WOLLONGONG CITY COUNCIL

# Traffic Committee Minutes of Meeting

9 May 2023

Item 2.1 – EAST CORRIMAL- Thalassa Avenue - Proposal of Centre Linemarking

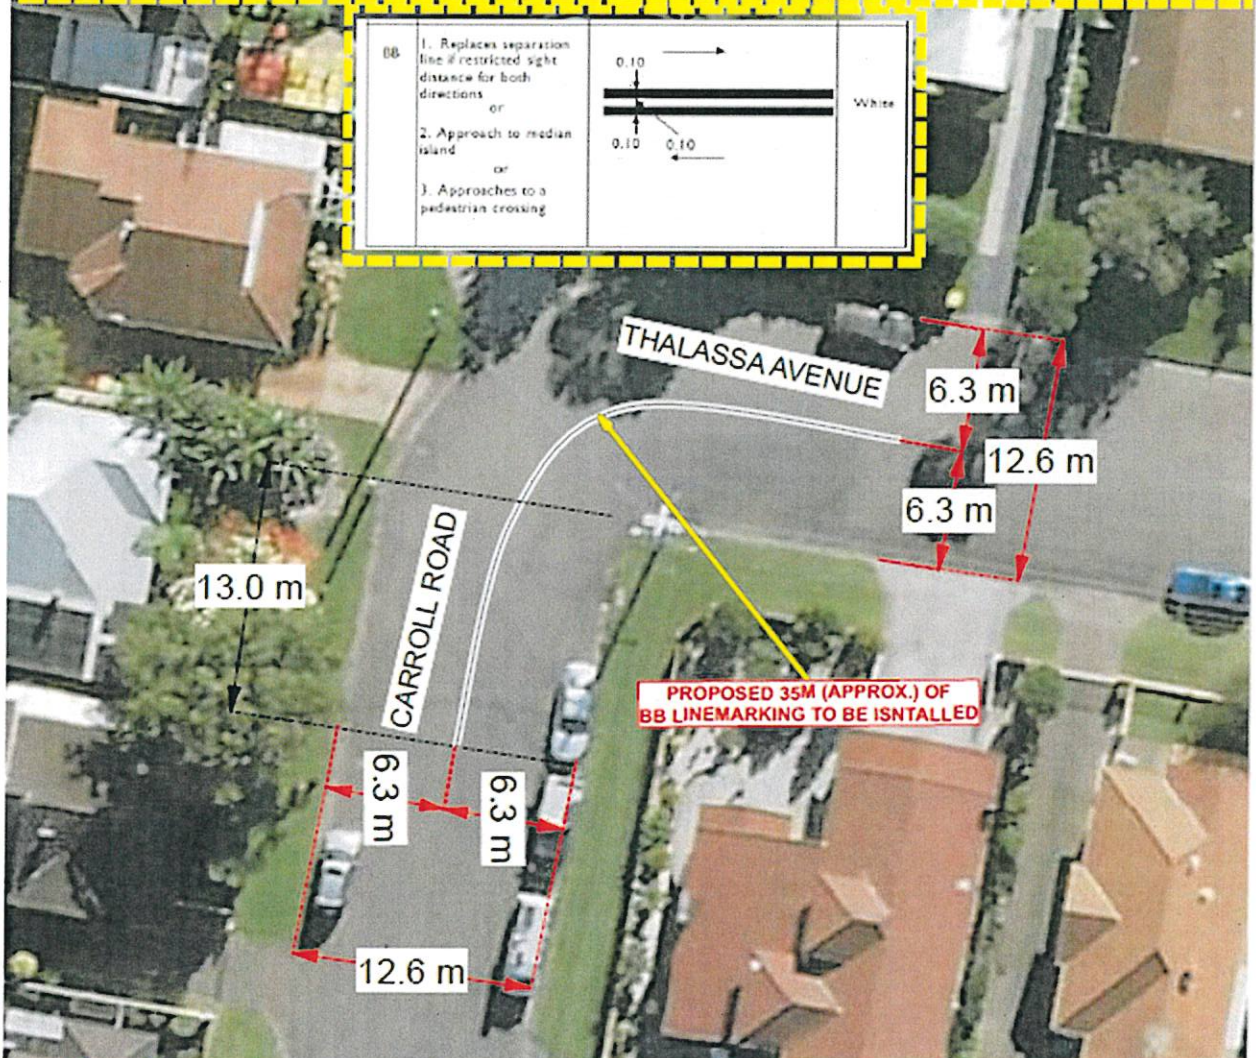
Council has recently been informed of potential road safety concerns at the bend of Thalassa Avenue and Carroll Road, East Corrimal. A customer has reported that vehicles are cutting the corner which could create a risk of a head on collision. Council proposes to install double barrier (BB) line marking instead of parking restrictions to promote lane discipline and encourage improved driver behaviour. No parking restrictions are proposed.

The Traffic Committee endorse the attached plan.

Item 2.2 – MANGERTON, Norman Street, Proposed BB Line

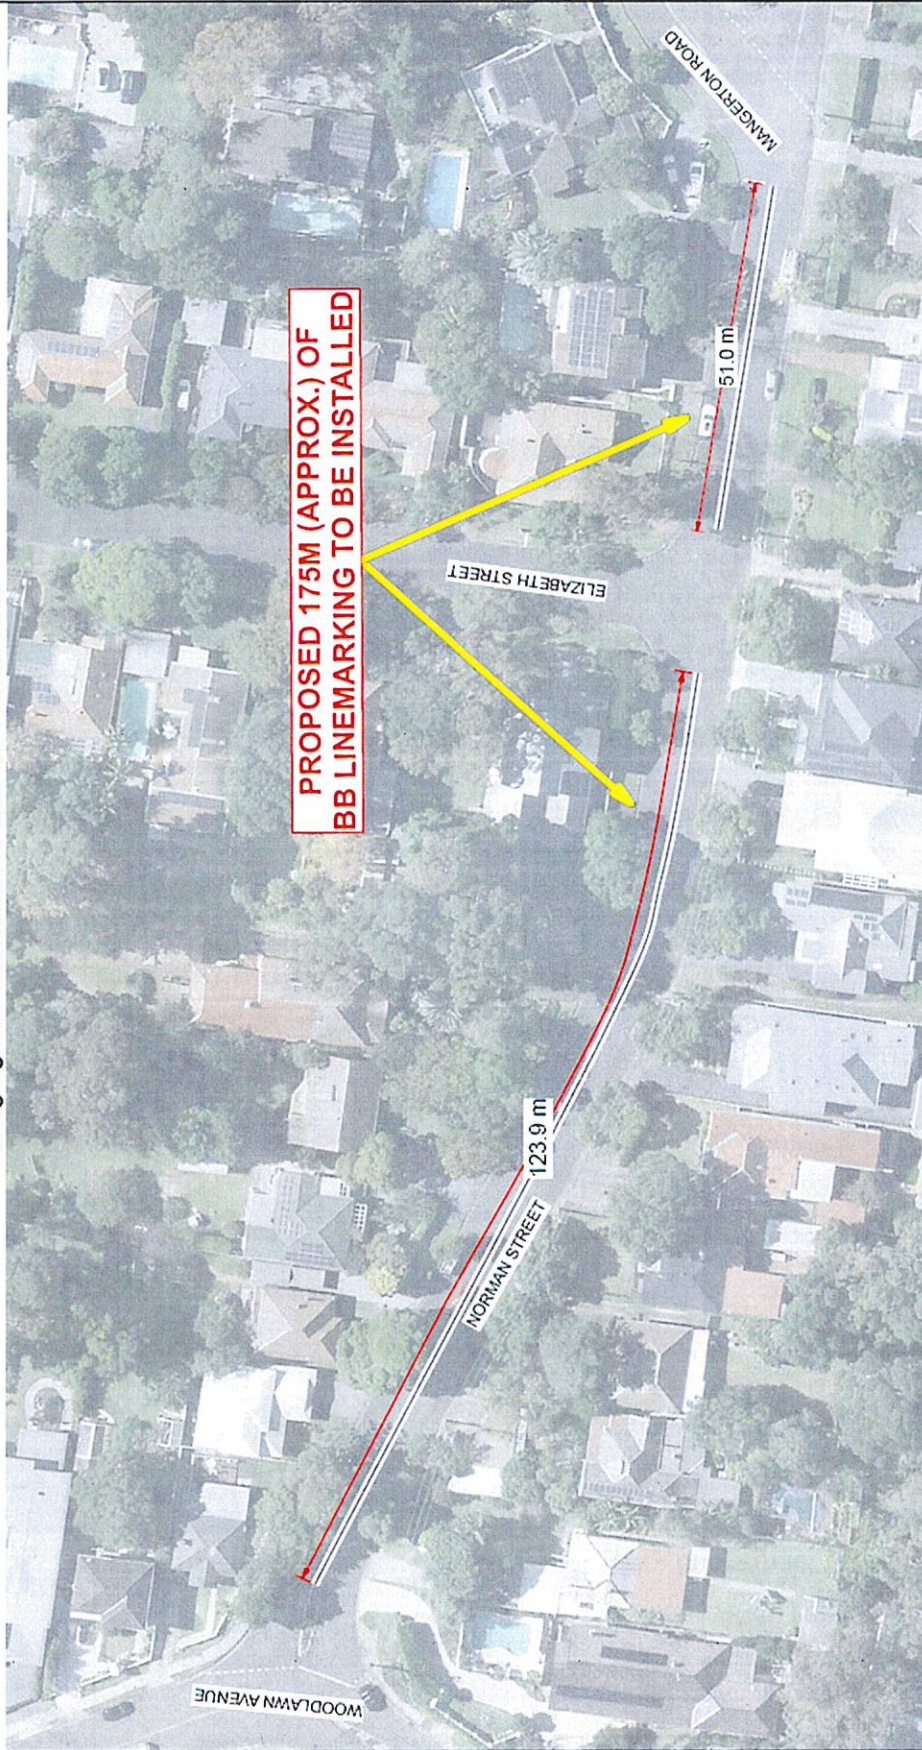
Council has recently been informed of potential road safety concerns at the bend of Norman Street, Mangerton, from Woodlawn Avenue to Mangerton Road. A customer has reported to Council that vehicles are not staying within the lane which has created an increased risk of a head on, especially due to the road geometry which limits sight distance.

The adjacent collector roads Woodlawn Avenue and Mangerton Road have centreline marking. Norman Street is also a collector road and is 10.5m to 11m wide. Council proposes centreline markings along the length of the street as shown in the plan, connecting to the existing centrelines at either end. The existing width of the road means that on-street parking will still be permitted with BB lines while clearly delineating the travel lanes.

The Traffic Committee endorse the attached plan.

Item 2.3 – FIGTREE, Bellevue View Road – Shared Path Linemarking, Page 1 of 2

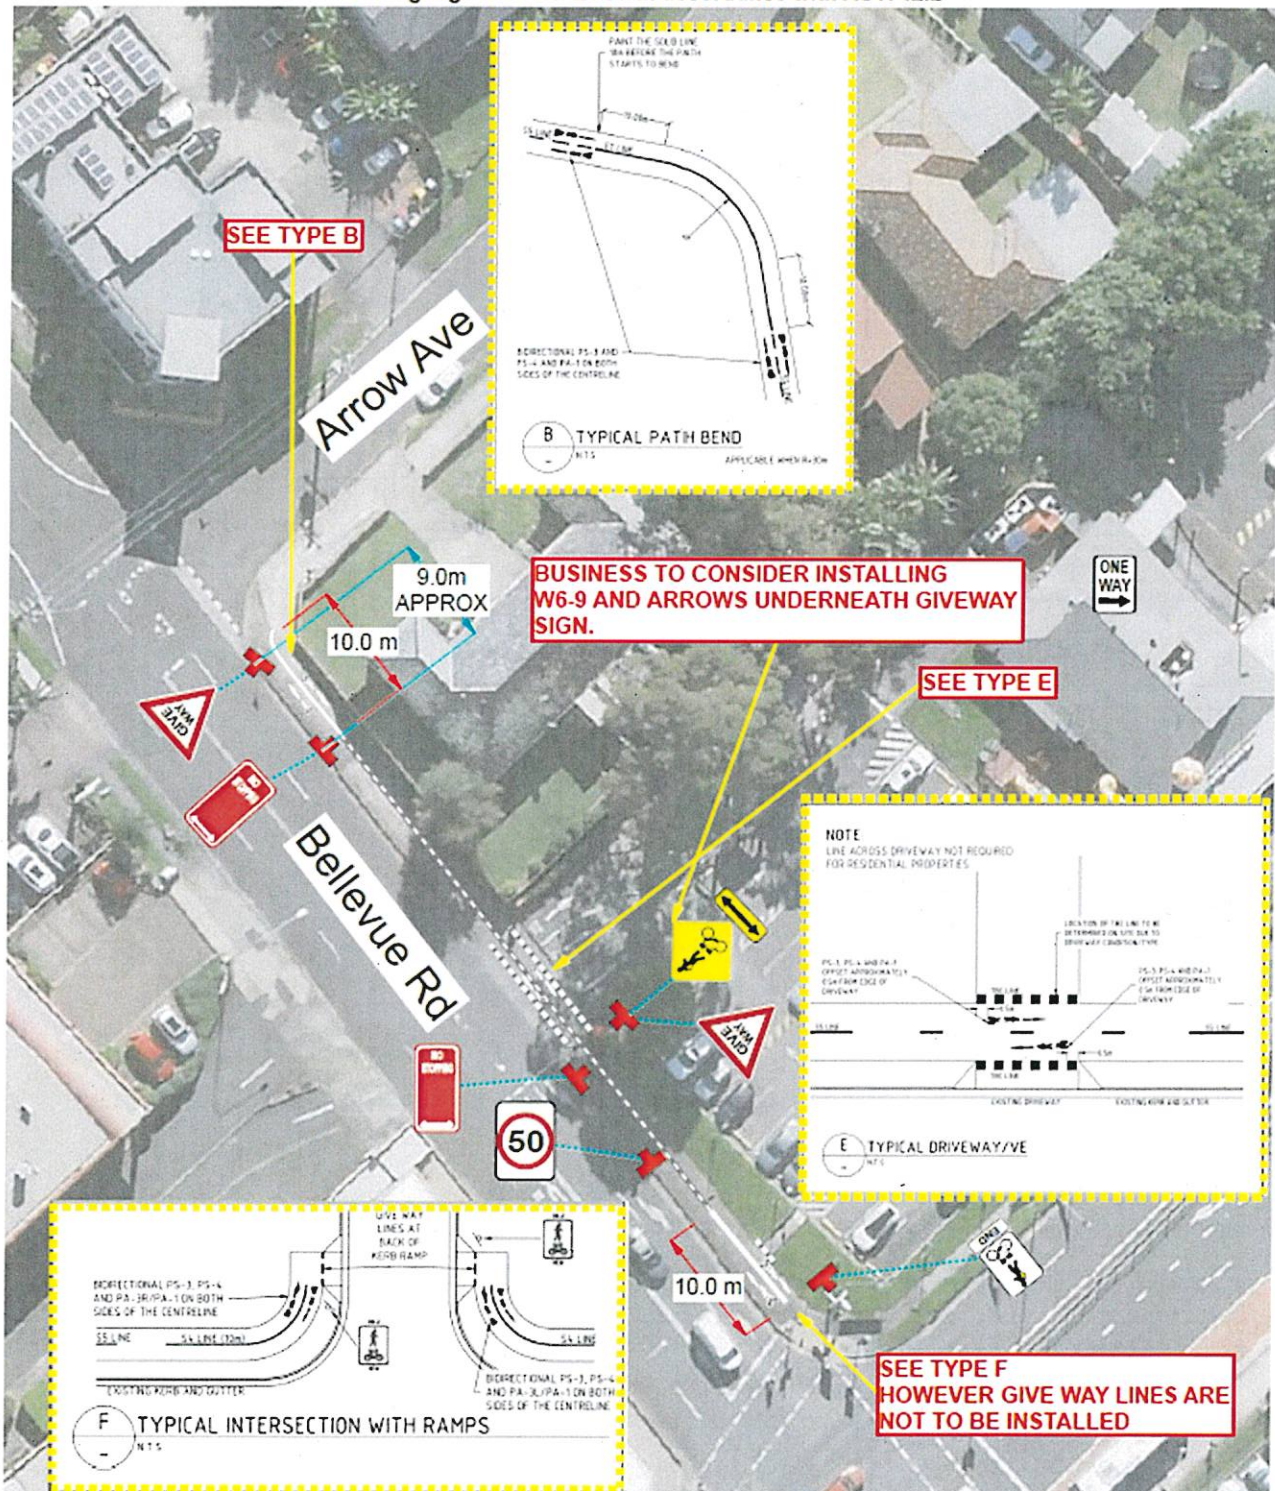
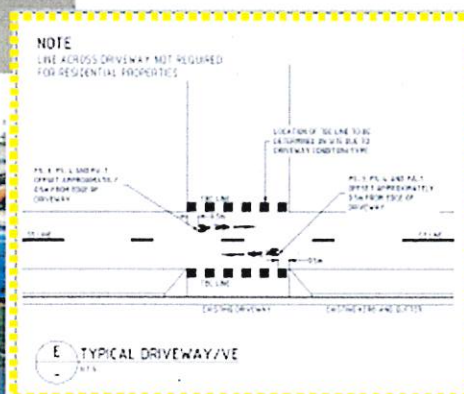
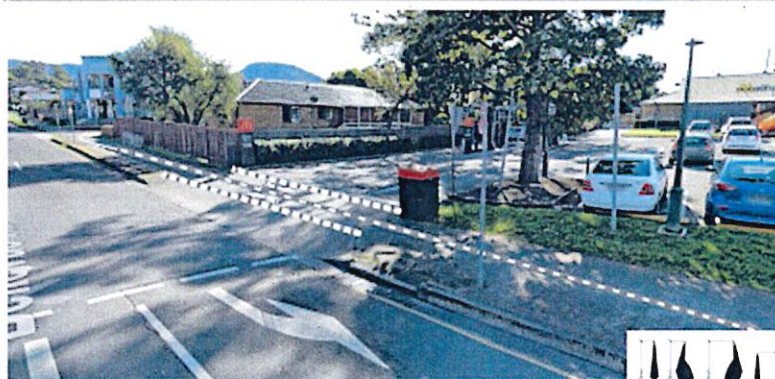
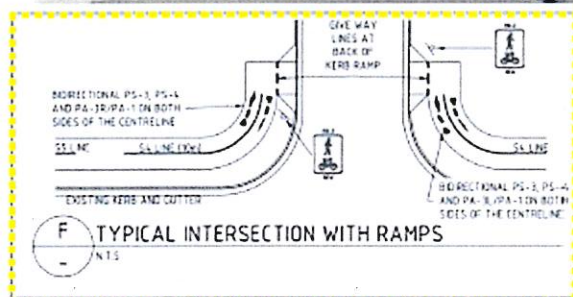
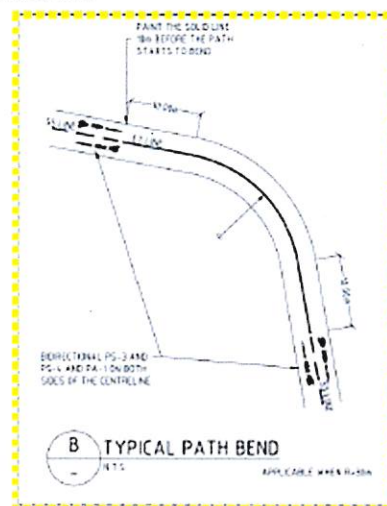
Council's Transport team received reports of ongoing concern over the Bellevue Rd entrance and exit to the Figtree McDonalds. To address the concerns raised, Council is proposing the installation of shared-path linemarking on the northern shared-path of Bellevue Rd from Arrow Rd to the Princes Highway.

The Traffic Committee endorse the attached plan.

Council will monitor driver behaviour following installation and review the need for additional signage.

Item 2.4 – KANAHOOKA, Fields St and Thirroul Rd – Intersection Linemarking

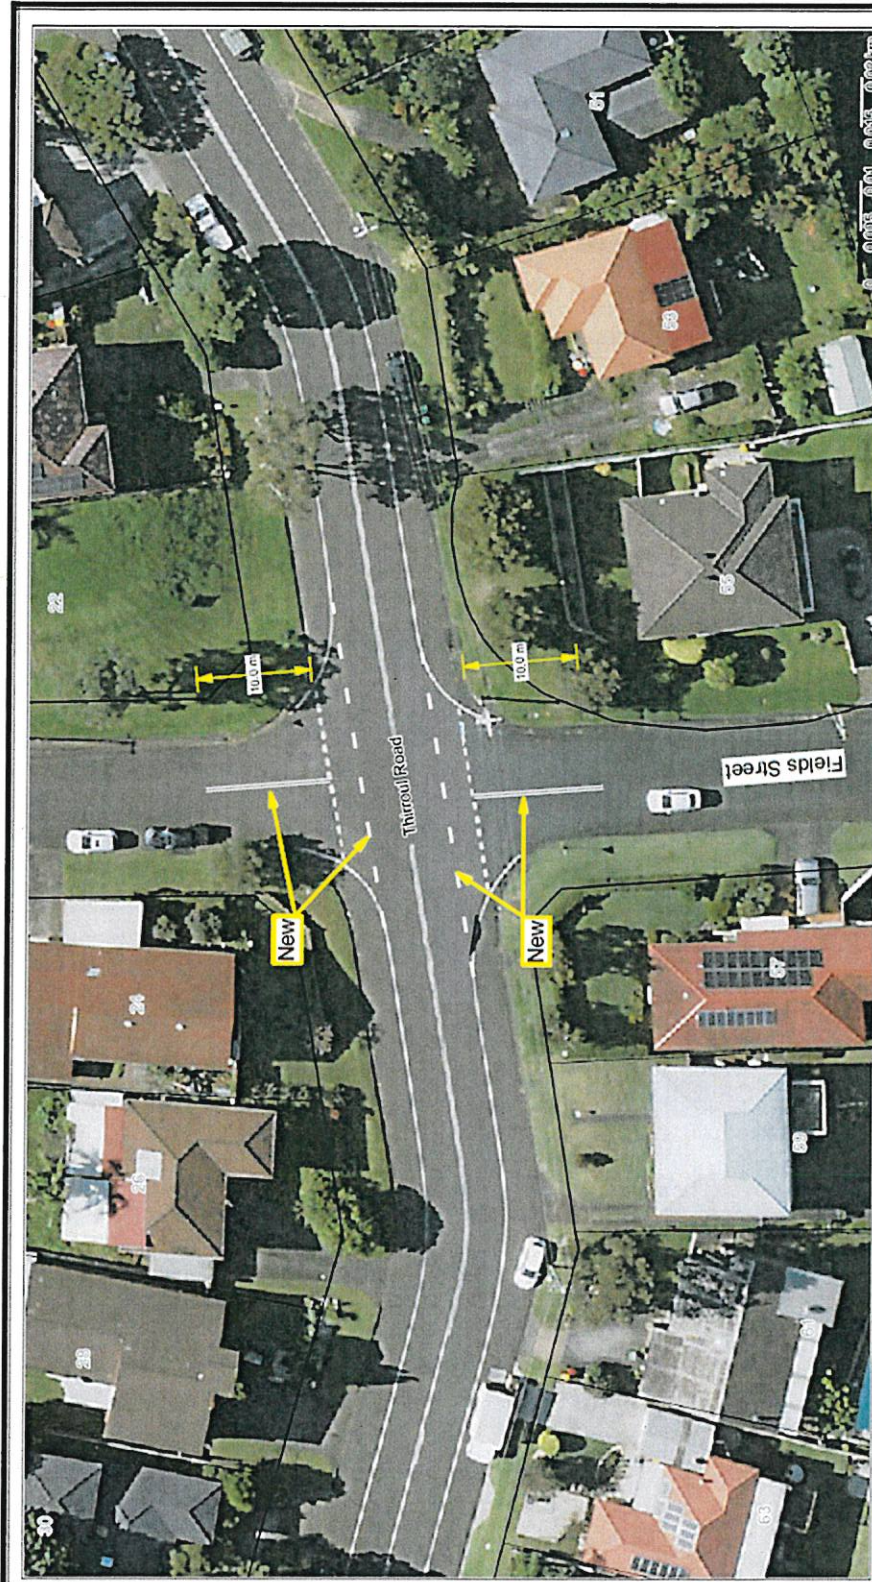
Council has recently been informed of near misses and sight distance concerns at the intersection of Thirroul Road and Fields Street, Kanahooka. Council officers inspected the area and noted that the road geometry, grades and parking arrangement at the intersection may impact drivers sight lines. To improve sight distance at the subject intersection, Council is proposing the installation of continuity (C1) lines, to enable vehicles to edge out further into the intersection, and dividing barrier (BB) lines, to keep vehicles on the correct side of Fields Street as they approach the intersection.

The Traffic Committee endorse the attached plan.

### Item 3.1 – THIRROUL, Cliff Parade – Thirrour Seaside and Arts Festival

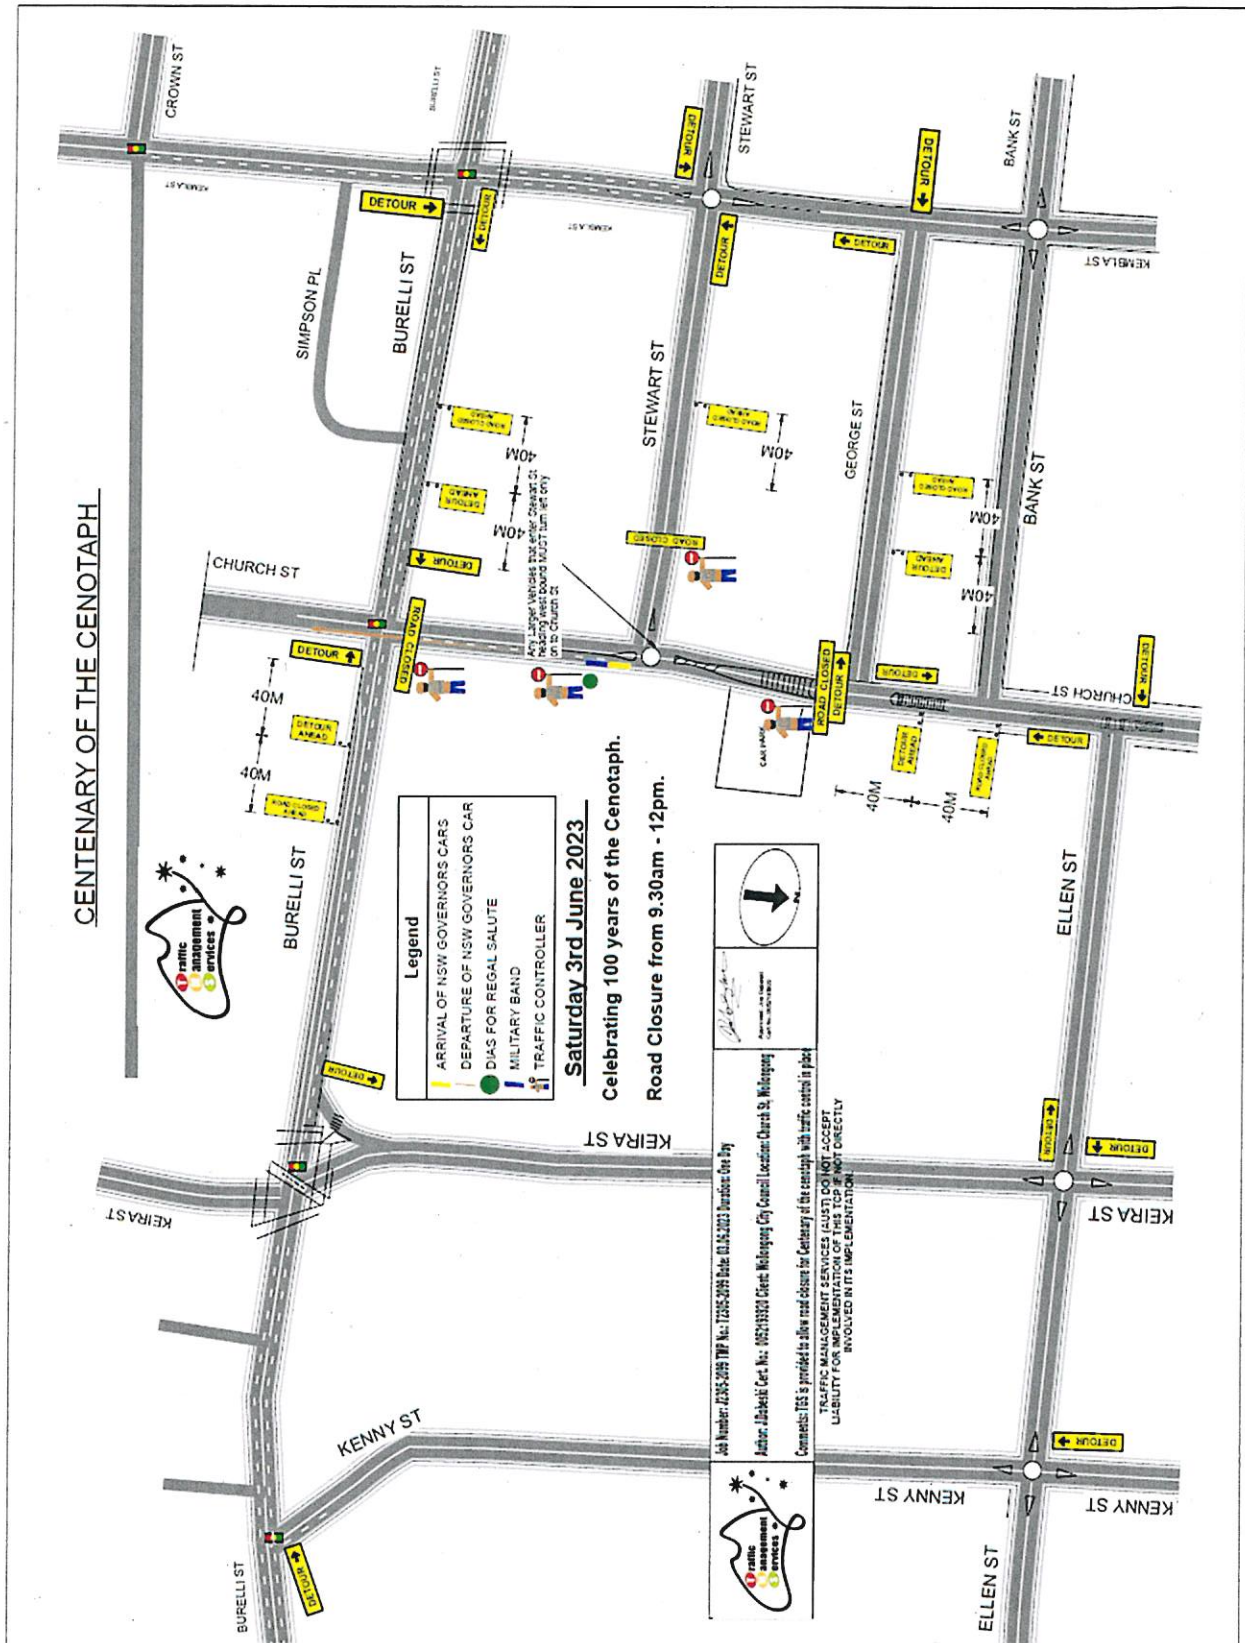
The road closures be approved subject to the submitted Traffic Control Plans and [Council's Standard Conditions for Road Closures](#).
